Product Service Group CE Audio

Service Information

CHANGES DURING PRODUCTION

MMPWR 100W MODULE - MAINS BOARD

Figure 1

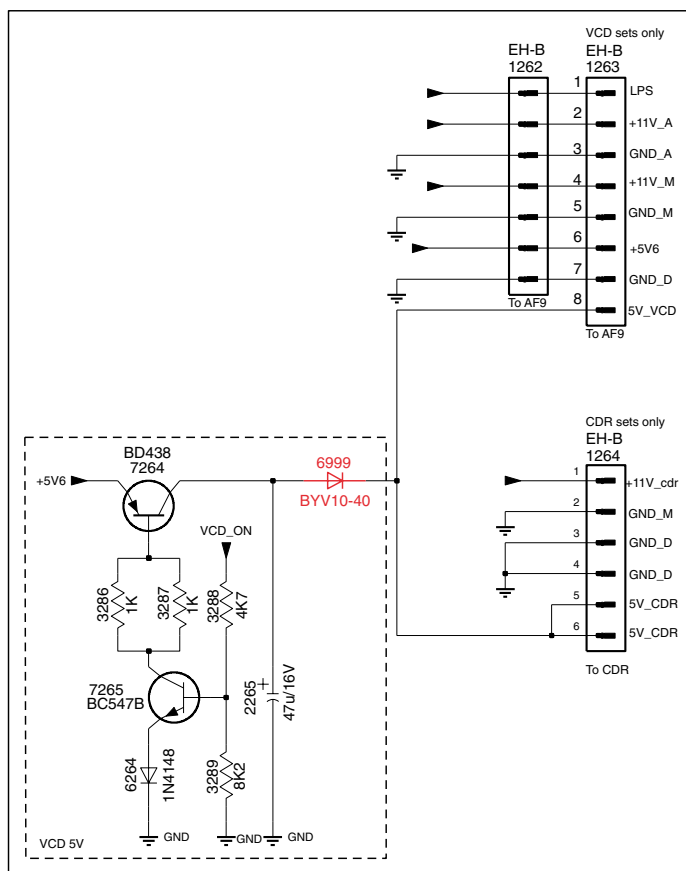
*From production week 0218 onwards pt.5 board is introduced due to addition of diode 6999 into same location as 9495 (see Figure 1). This change is for other set application and the board can be recognized by the printing mark 12NC - 3139 113 34345.

MAINS BOARD - COPPER SIDE VIEW

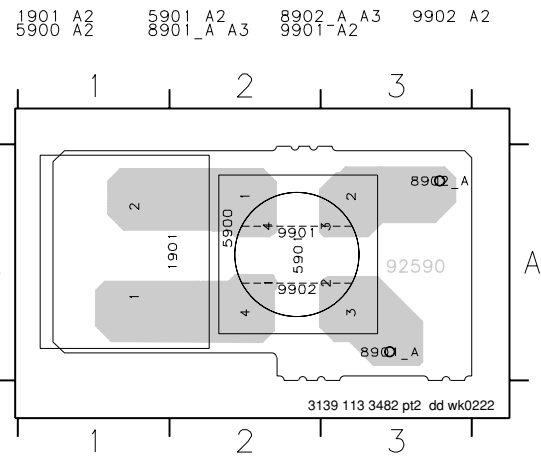
*From production week 0218 onwards new Mains & Mains Socket pc boards is introduced due to process improvement. The board can be recognized by the printing mark 12NC - 3139 113 34822. For this reason new pc board layout is enclosed.
